# **2014 - 2016 Corvette: Service Bulletin: #PI1116A: Door Rattle Noise from Outside of Vehicle During High Radio Volume or High Bass Levels - (Sep 14, 2016)**

<b>Subject:</b>	Door Rattle Noise from Outside of Vehicle During High Radio Volume or High Bass Levels
<b>Models:</b>	2014-2016 Chevrolet Corvette
<b>Attention:</b>	This PI also applies to any of the above models that may be Export from North America vehicles.

This PI has been revised to remove a breakpoint and add the 2015-2016 Model Years. Please discard PI1116.

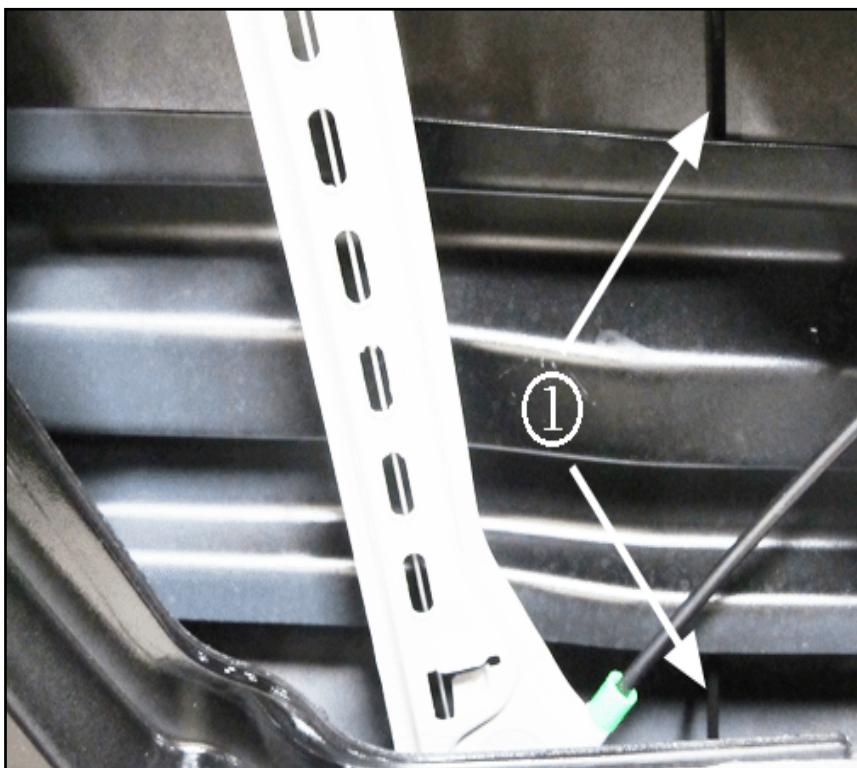
The cause of this condition may be voids in adhesive (1), leaving gaps between the inner door beam and the door skin.

The graphic above shows an example in which a tie strap (1) was passed through a 15-20 cm (6-8 in) length gap where the adhesive was missing towards the center of the door.

This can also occur in the front and/or rear area of the door beam; with the condition sometimes more evident in the front area (shown above) where the radio speaker is mounted.

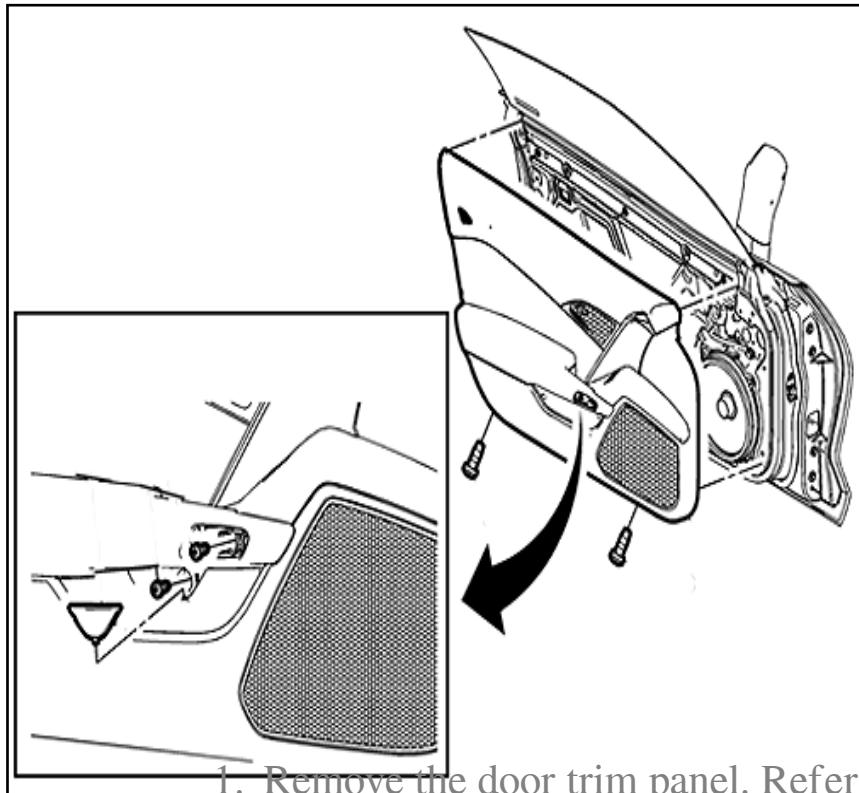
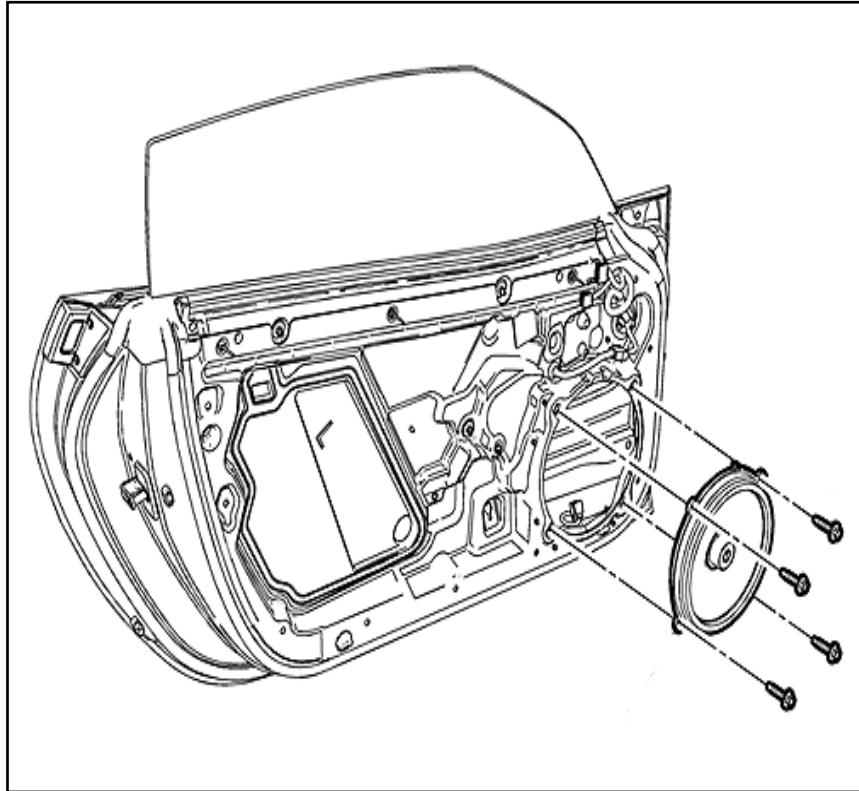
Inspect the front side door beam and door skin gap for voids and add a bead of butyl ribbon sealer in those areas following the steps below:

2. Inspect the gap between the inner door beam and door

**Tip:** Use of a trim stick, or equivalent tool, may help to work the sealer into the gap.

1. Add a bead of \*3M Windo-Weld™ Ribbon Sealer P/N 08611, or equivalent, to the areas where adhesive is missing. Work the sealer so there is a continuous bead in the gap from the rear of the door beam to the front.
2. Reinstall the front door lower speaker and test to make sure the rattle noise is eliminated. Refer to *Radio Front Side Door Speaker Replacement* in SI.
3. Reposition the water deflector and reinstall the door trim panel. Refer to *Front Side Door Trim Replacement* in SI.
